1 | P802.11wTM/D1.~~01~~02

2 |
3 | **Draft Amendment to Standard for Information**
4 | **Technology - Telecommunications and Information**
5 | **Exchange Between Systems - LAN/MAN Specific**
6 | **Requirements -**
7 |
8 |
9 |

16 | **Amendment <number> : Protected Management**
17 | **Frames**
18 |
19 |

Table 0—Change history

Figure 13—Establishing pairwise and group keys

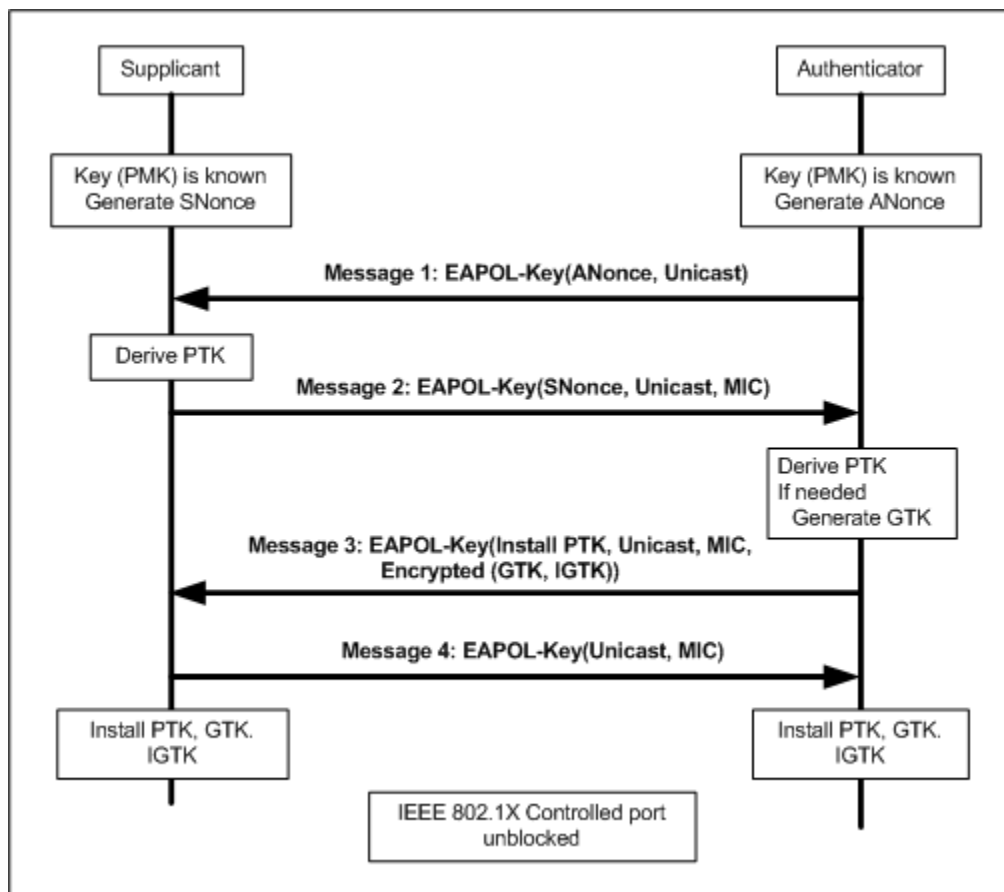
Replace Figure 13 with the following figure, with the changes being the inclusion of “IGTK, DHV” in message 3 and in both the Supplicant and Authenticator boxes that begin with “Install”:

Figure 14—Delivery of subsequent group keys

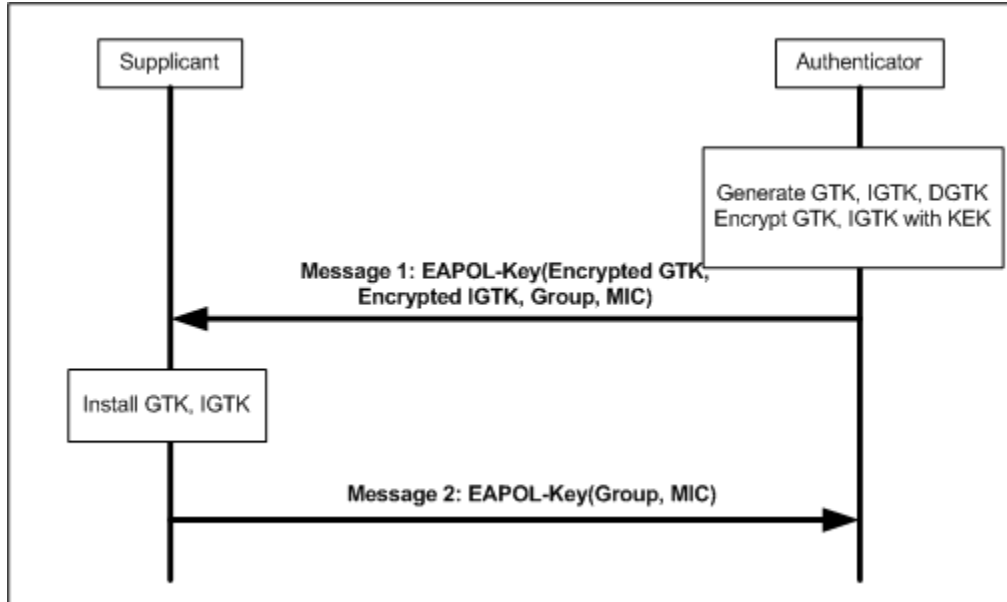
1 *Replace Figure 14 with the following figure, with the changes being the inclusion of “Encrypted IGTK”*
 2 *in Message 1, “IGTK, ~~DHV~~” in the Authenticator box beginning with ‘Generate’ and “IGTK” in the*
 3 *Supplicant box beginning with “Install”;* *the update to the 2nd box on the right has intentially fixed from*
 4 *the 802.11ma D9.0 draft to correctly state “Encrypt GTK, IGTK with KEK”:*
 5
 6
 7
 8
 9

Figure 136—Nonce Construction

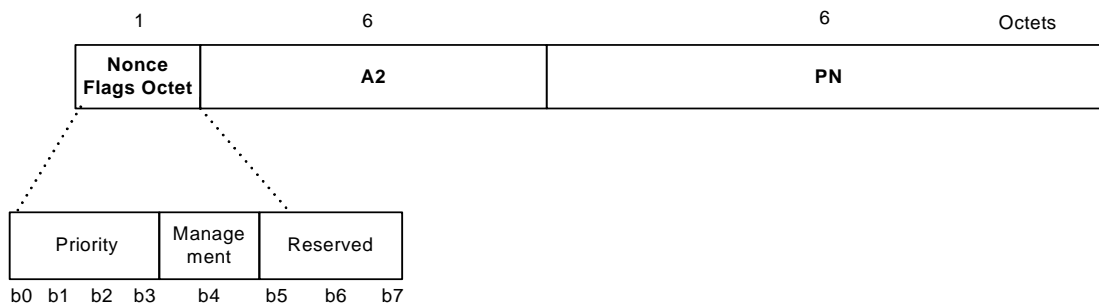
Replace Figure 136 with the following figure "replacing "Priority Octet" with "Nonce Flag Octet", and addition of "Management" as bit 4 of this octet.":

Figure 106a—Disconnect Group Key Hierarchy

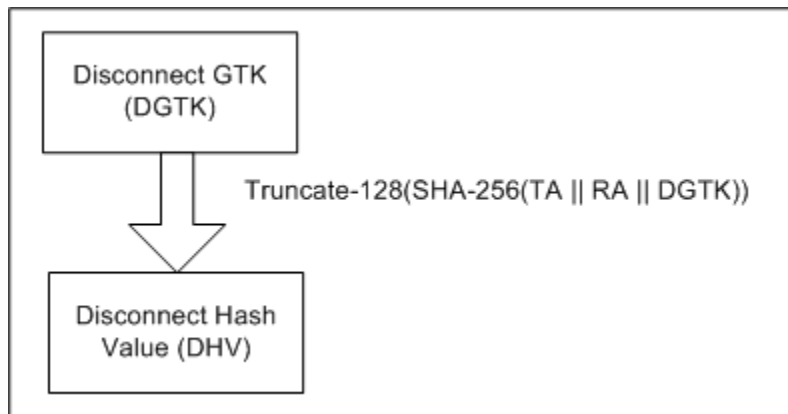
~~The Disconnect Group Key Hierarchy uses SHA-256 to derive the DHV from the DGTK, as shown in Figure 106a. The DGTK is used to provide source authentication for broadcast and multicast Deauthenticate and Disassociate management frames.~~

Figure 152—Sample Group Key Handshake

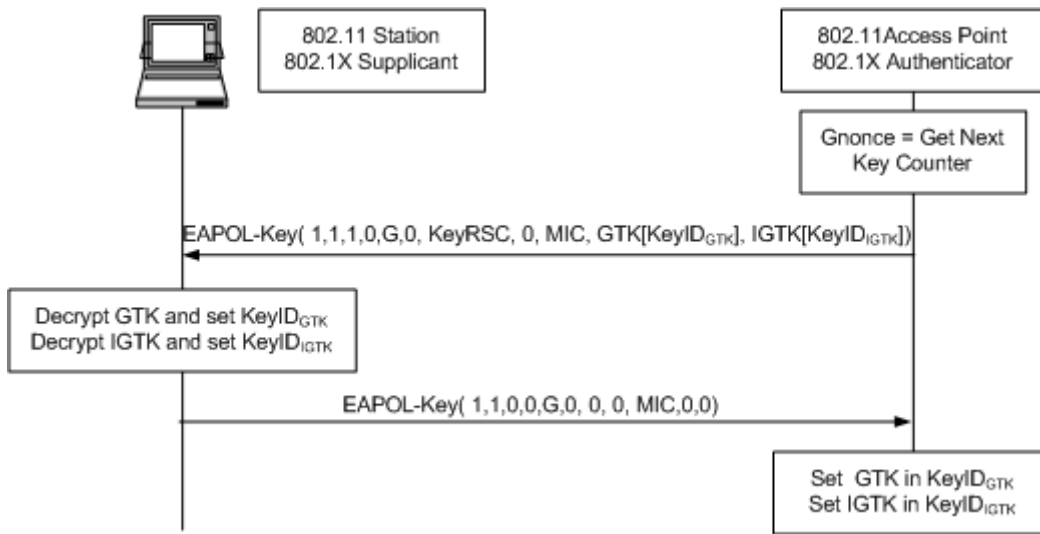
Replace Figure 152 with the following Figure, with the updated including IGTK ~~and DHV~~ on the first EAPOL-Key message and 2nd supplicant box, adding "0,0" on the second EAPOL-Key message and IGTK and new subscripts to the last Authenticator box:

Figure 153—RSNA Supplicant key management state machine

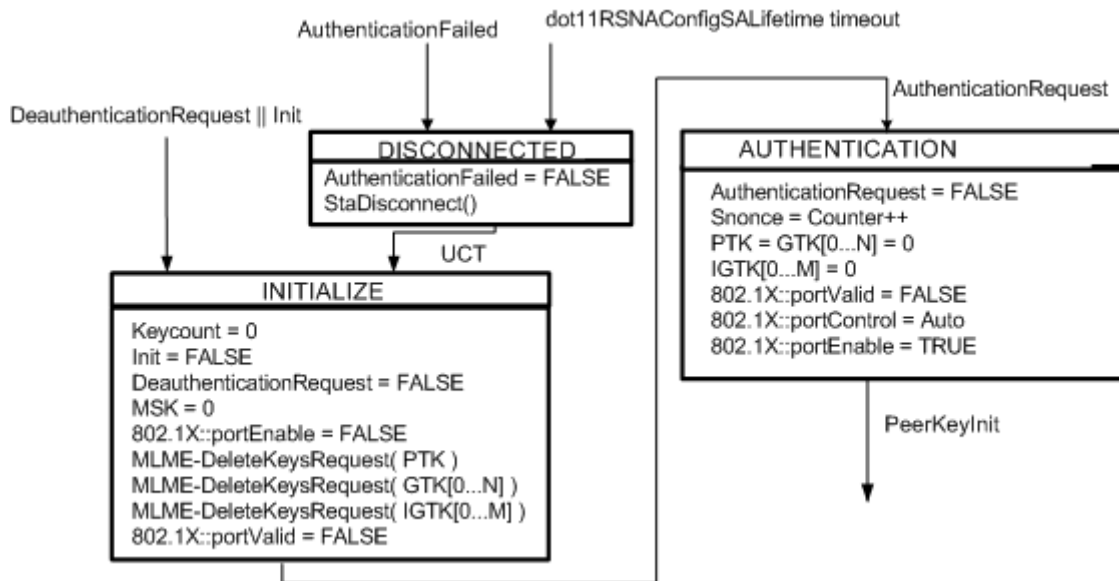
Replace Figure 153 with the following figure adding “IGTK[0...N] = 0” in the “AUTHENTICATION” box and “MLME-DeleteKeysRequest(IGTK[0...N])” to the “INITIALIZE” box:

Figure 155—Authenticator state machines, part 1

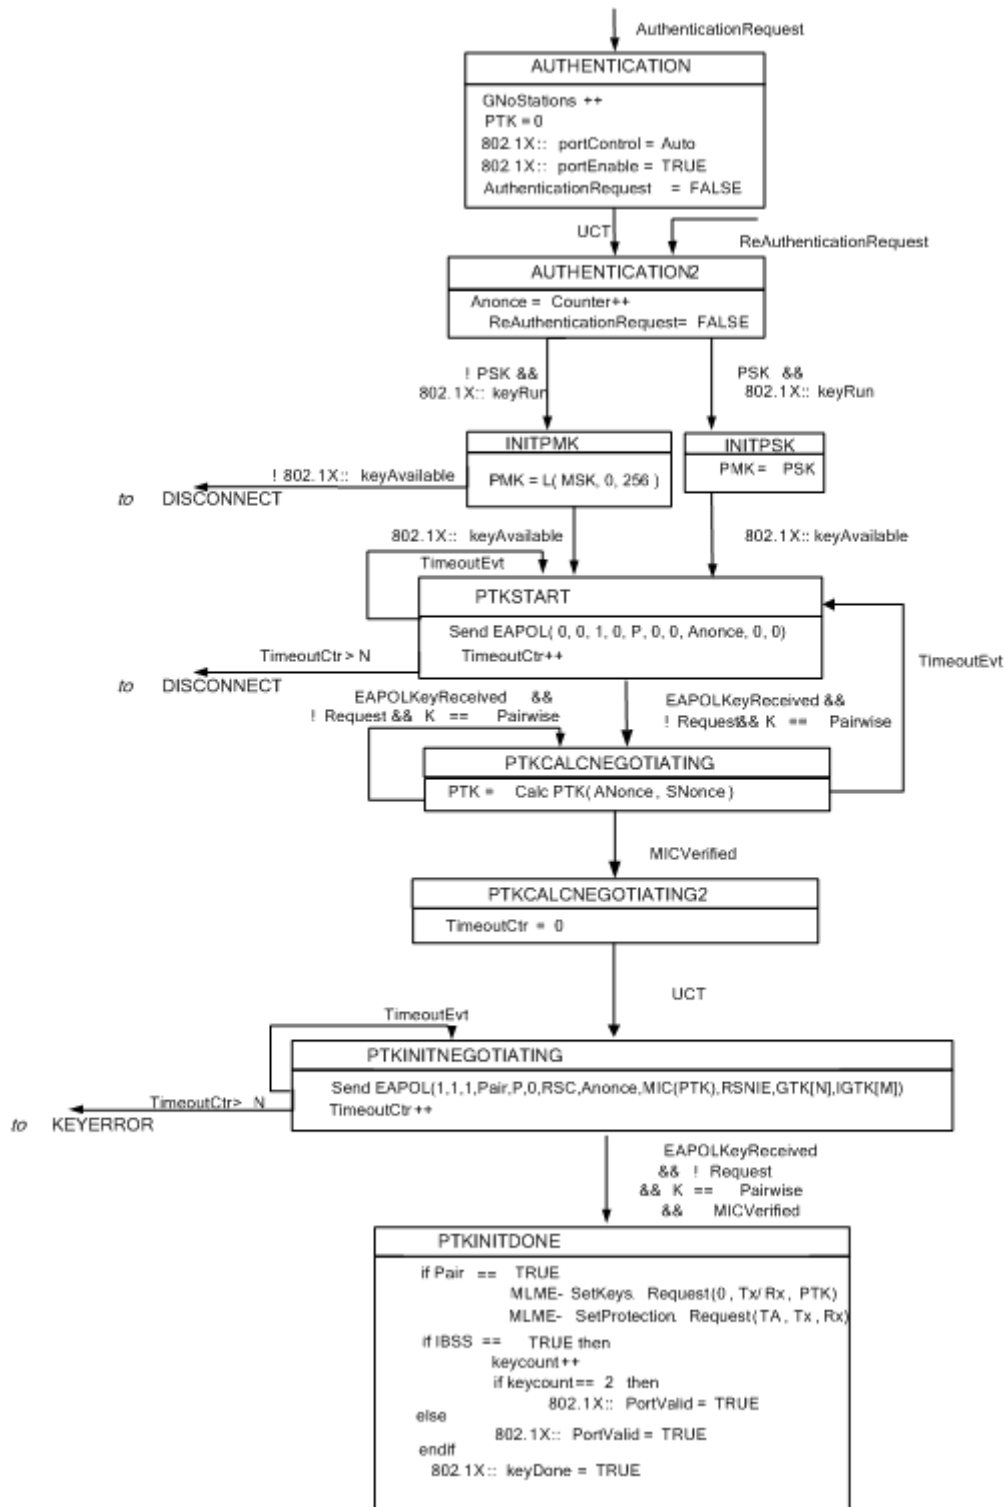
Replace Figure 155 with the following Figure, with the updates being the insertion of "IGTK[M]" in the PTKINITNEGOTIATING box:
